**THE CORPORATION OF THE DISTRICT OF SAANICH**

**TO:** Mayor and Council  
**FROM:** Colin Doyle,  
Manager of Transportation and  
Infrastructure Planning

**DATE:** November 19, 2003  
**FILE:** EPW100-20 Lochside  
**XRef:** EPW 00-20

**SUBJECT: Lochside Drive Action Plan**

Figure 3: Recommended Lochside Drive Action Plan Improvements

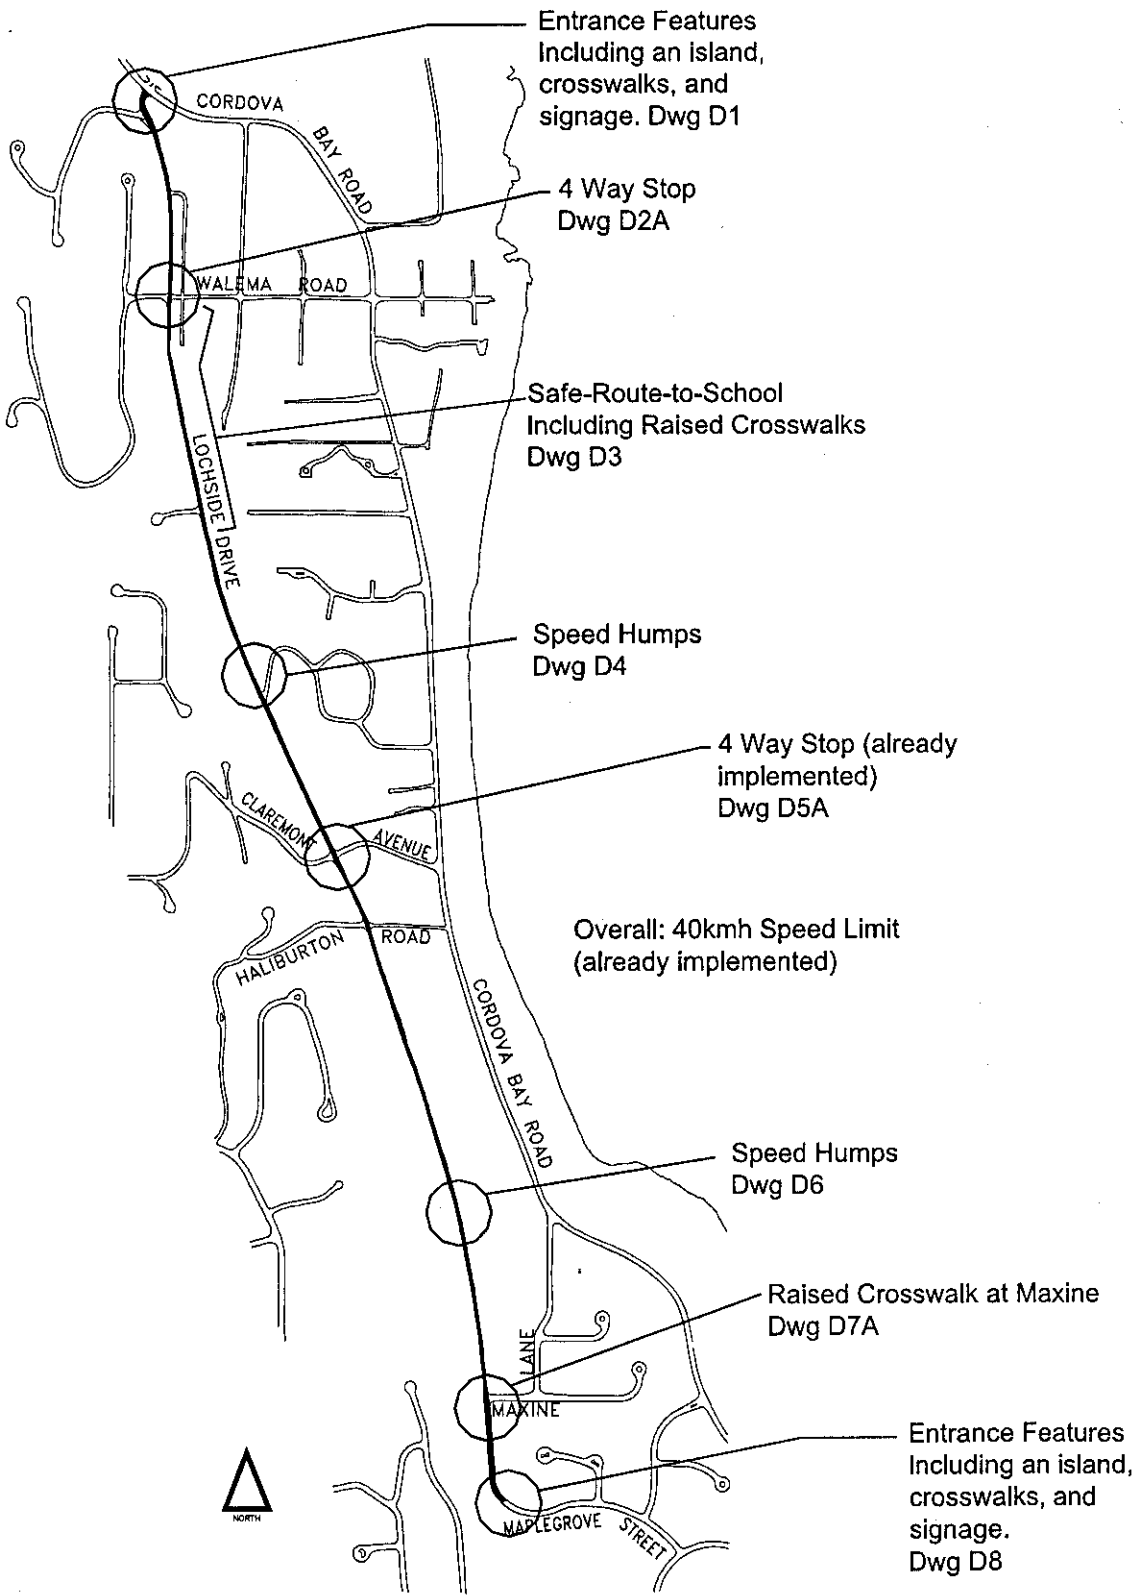
- ▶ Some of the features on the drawing are already in place.
- ▶ There will be an entrance feature, an island, crosswalks and signage at Lochside Drive and Cordova Bay Road. The intent will be to give people a sense that a different type of road use is ahead. The appearance of the signs is critical to send the appropriate message.

- ▶ The intersection at Walesa Road will have a four way stop and a reduction of the overall size of the intersection.
- ▶ A paved, off road pathway and raised crosswalks have been provided as a safe-route-to-school near the Doumac Ravine.
- ▶ Two speed humps will be installed at Abbey Road. The speed humps will be spaced to encourage speeds of 40 km/h.

- ▶ A four way stop has already been implemented at Claremont Avenue. A bench may also be provided.
- ▶ The pavement will be narrowed at Maplegrove Street and entrance features, including an island, crosswalks and signage will be added.

- ▶ Signs need to clarify which side and direction pedestrians and cyclists travel on.
- ▶ Naturescaping principles should be used in new landscaping.

Moved by V. Faulkner and seconded by B. Townsend: "That the Bicycle Advisory Committee approves the plan for Lochside Drive Action Plan Improvements as presented and requests that the introduction of signs at the north and south ends of the project be designed by a multi-disciplinary team and that the design for the signs include an artistic component that recognizes the 'gateway' function that the signs are intended to serve."

- Speed humps are not that effective, they just annoy drivers.
- A narrow island with a rumble surface would be effective.
- The idea is to convey that Lochside Drive is a special road and perhaps changing the paving materials or making it appear more like a lane and not a road would be a good idea.
